1958 Agreement – Consideration of draft corrigenda to existing Regulations submitted by GRE

Proposal for Corrigendum 1 to the 04 series of amendments to Regulation No. 10 (Electromagnetic compatibility)

Submitted by the Working Party on Lighting and Light-signalling*

"Figure 3

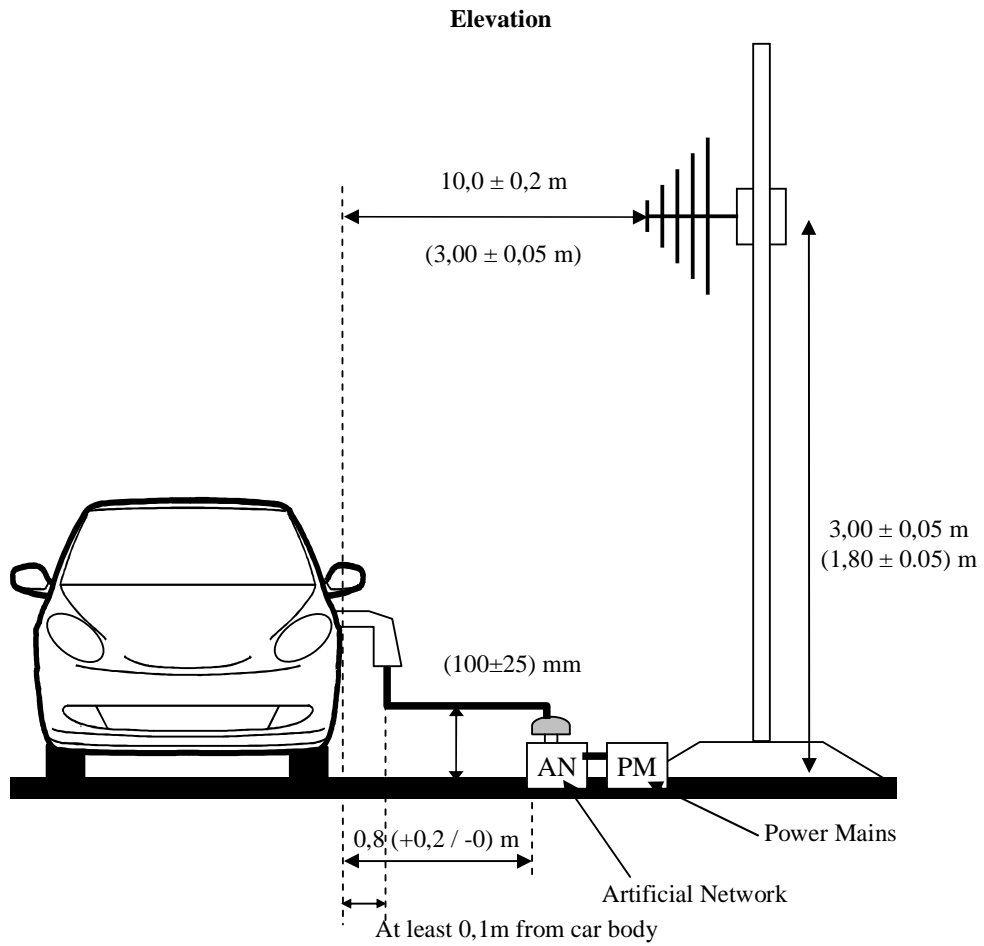
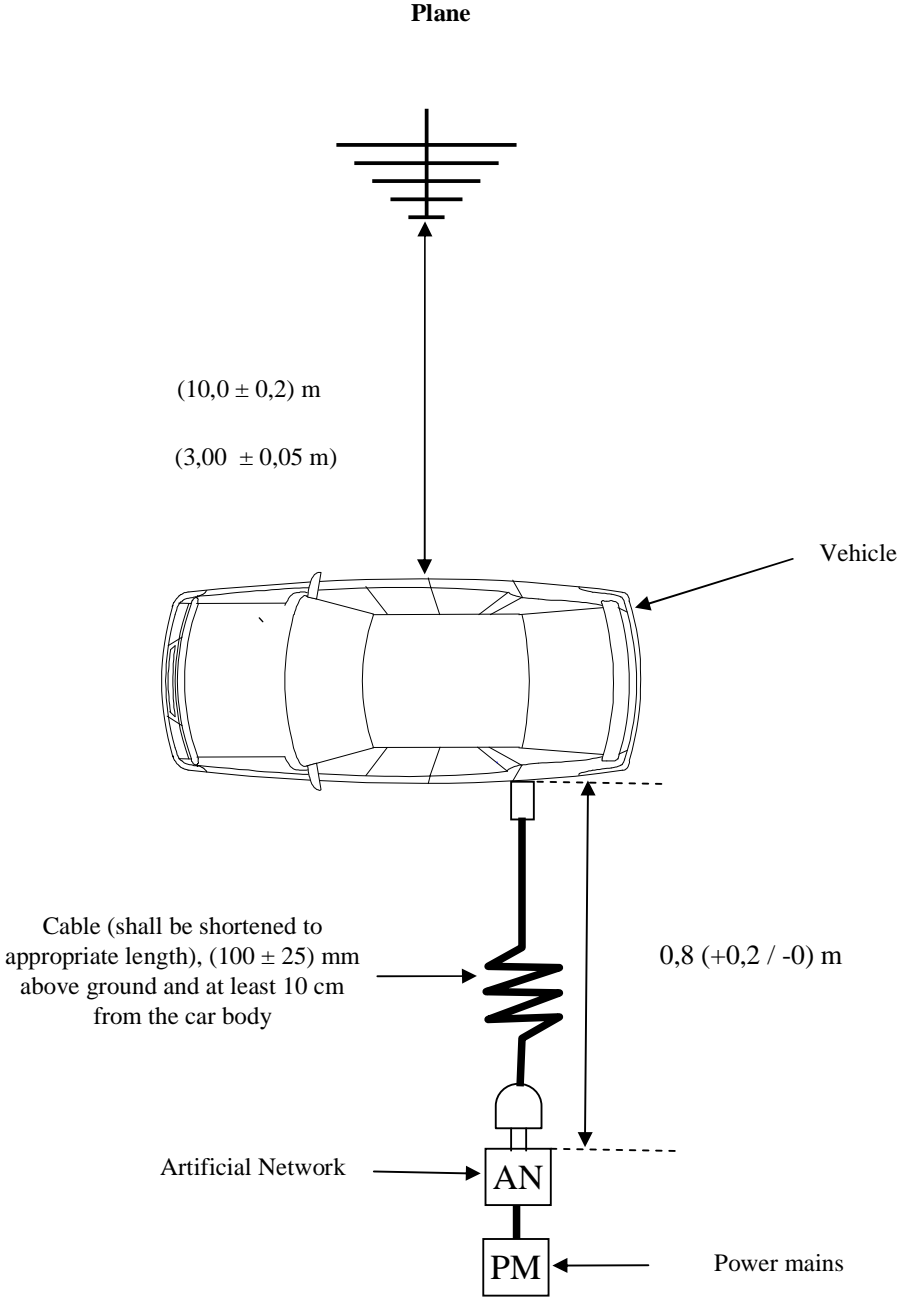
Figure 3, correct to read:

"Figure 4

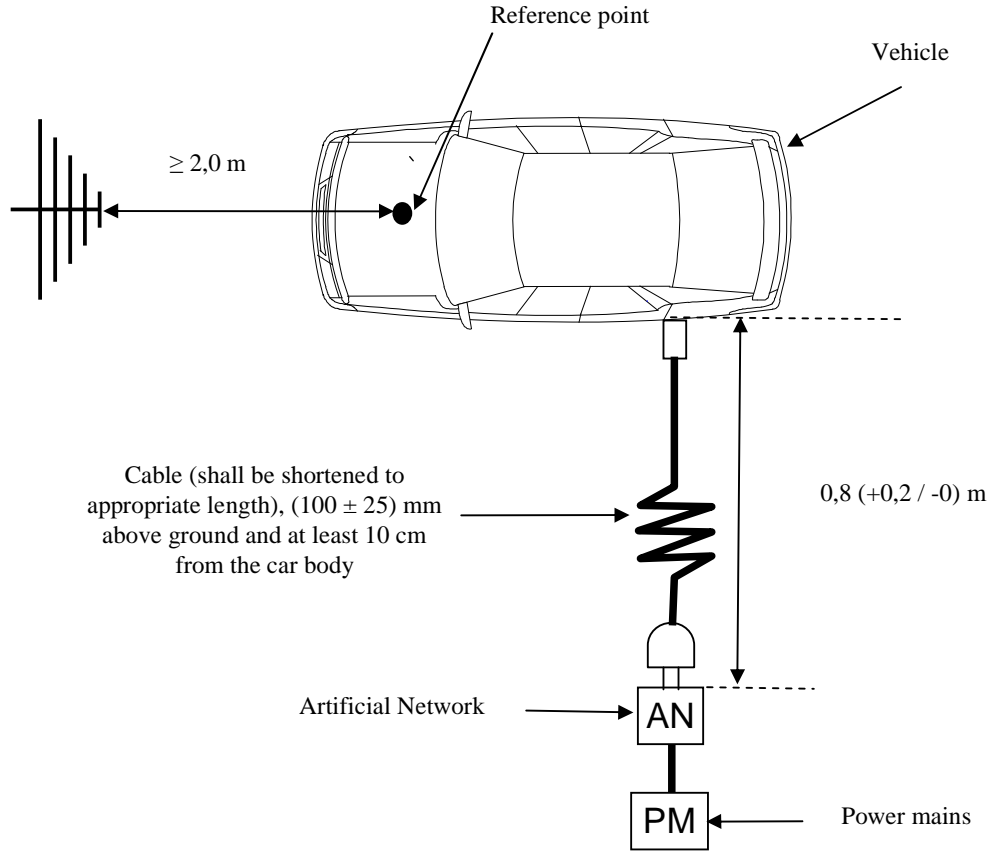
Figure 4, correct to read:

"Figure 1
Vehicle in configuration "RESS charging mode coupled to the power grid"

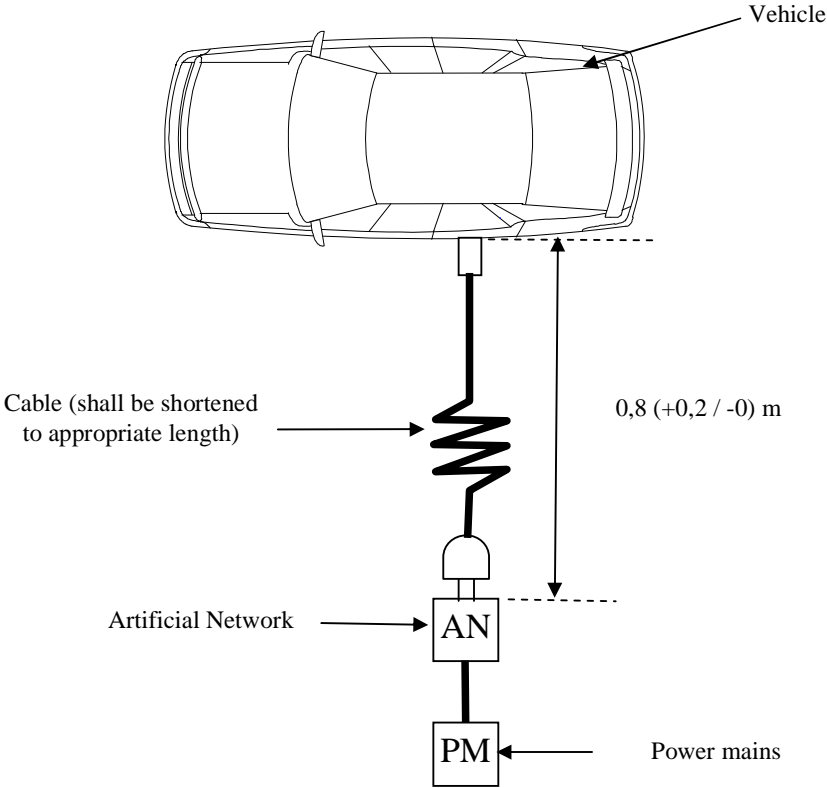
Figure 1, correct to read:

"Figure 1

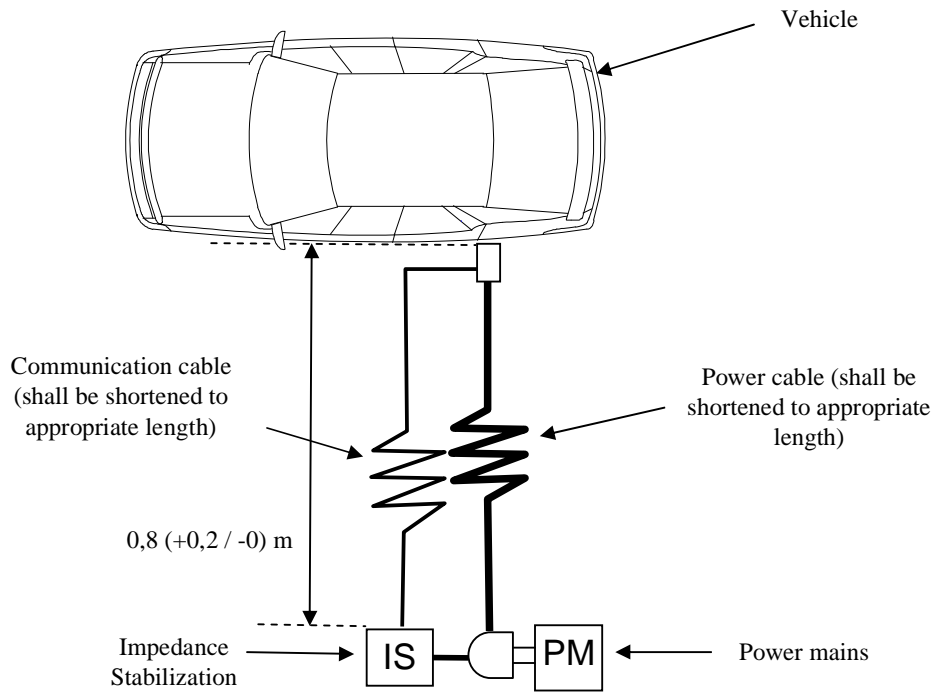
Figure 1, correct to read:
